# WIND GATE AT KALLISON RANCH

MASTER  
DEVELOPMENT  
PLAN  
ACRES: 369.44  
DATE : 04/28/05

TO: DAO/PW/COSA Date 8-10-05  
FROM: MOY C.E. - John LaRo  
PHONE NUMBER: 698-5051x219 FAX NUMBER # 698-5085  
ITEM NAME: Wind Gate @ Kallison Ranch FILE # 050220  
RE: Revised MDP - sidewalks review

Subject: Master Development Plan Wind Gate @ Kallison Ranch, A/P #1120220

WIND GATE AT KALLISON RANCH  
MASTER DEVELOPMENT PLAN  
SHEET 1 OF 1

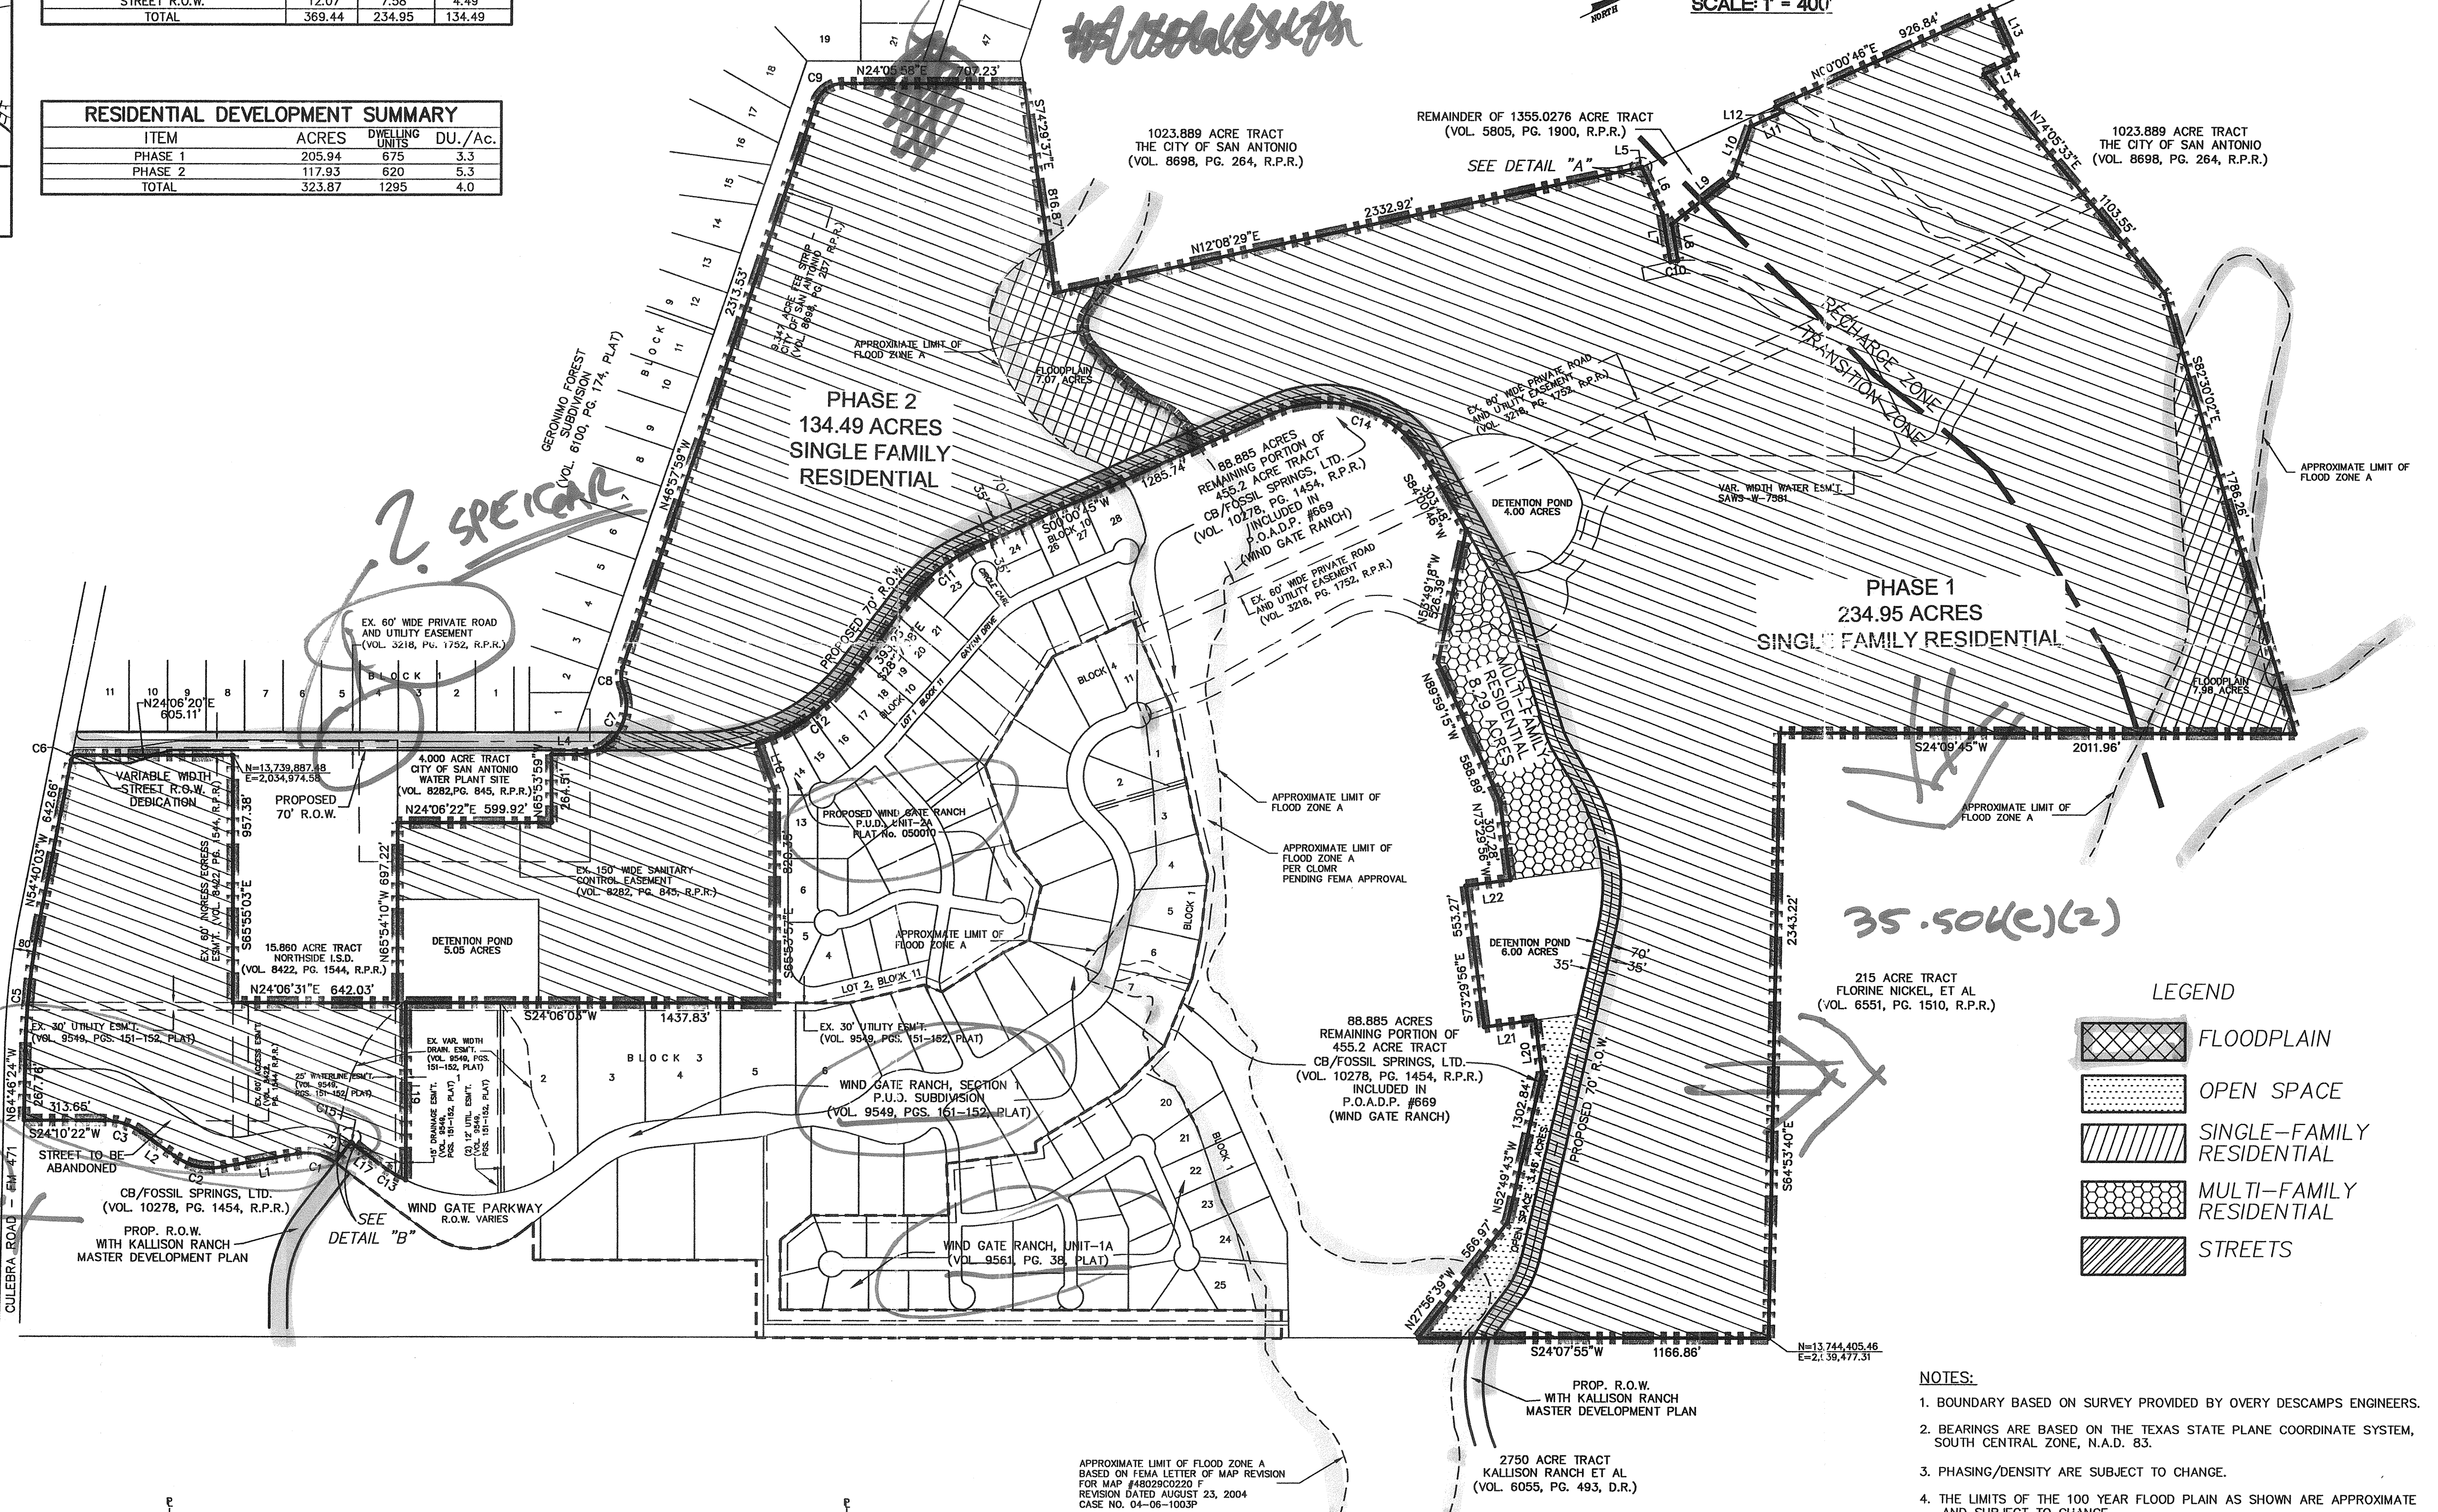
PLEASE ADD A 'GENERAL NOTE' TO PLANS STATING THAT  
SIDEWALKS WILL BE INSTALLED IN THE PUBLIC RIGHT-OF-WAY  
PER UDC ARTICLE 5, DIVISION 2: 35-506(q.)

Comments: - UDC. 35-B101, SHOW STREET CIRCULATION  
PER RID # 12; ANNOTATE MDP BOUNDARY,  
- UDC. 35-506(e)(2) projection of streets  
to the northeast of project  
Collector Road as shown on plan will  
require approval from prop # 3 land acquisition  
dept for shared Road.  
2005 MAY -2 P 2:46

- 1 • UDC 35-506(e)(8) Major Thoroughfare Plan designated arterial streets, and (g)(1) and (3) dedication of arterial - Culebra road/F.M. 471 is on the MTP and TXDOT roadway system requiring a min. of 120' ROW and TXDOT review.
- 2 • UDC 35-B101(f)(16) and (18) Planning, show street circulation, annotate MDP, and phasing limits
- 3 • UDC 35-506 (e)(2) projection of streets to the northeast of project
- 4 • Collector road shares ROW of City Prop. 3 property at the southwesterly end of project tying into F.M.471/ Culebra road and will require approval from that department.

- UDC 35-B101, Show street circulation per RID # 12, annotate MDP boundaries
- UDC 35-506 (e)(2) projection of streets to the northeast of project
- Collector road shares ROW of City Prop. 3 property at the southwesterly end of project tying into F.M.471/ Culebra road and will require approval from that department.

Total required park/open space is 18.2 acres. 3.45 acres has been allotted, thus still leaving 14.75 acres missing. If you have any questions, please feel free to contact me. Thank you.

- Proposed roadways do not reference specific roadway classification, therefore it is not possible to assess UDC compliance for required bicycle facilities.
- Additional detail is requested.

I am providing this written response to the above comments as per our telephone conversation on October 19, 2005. I have included a copy of the revised MDP along with this letter. I believe that we have satisfactorily addressed the concerns listed, with the exception of the following:

A hand drawn exhibit which demonstrates the proposed R.O.W. with a 44 foot pavement section is enclosed. Please contact me with any questions at (210) 698-5051.
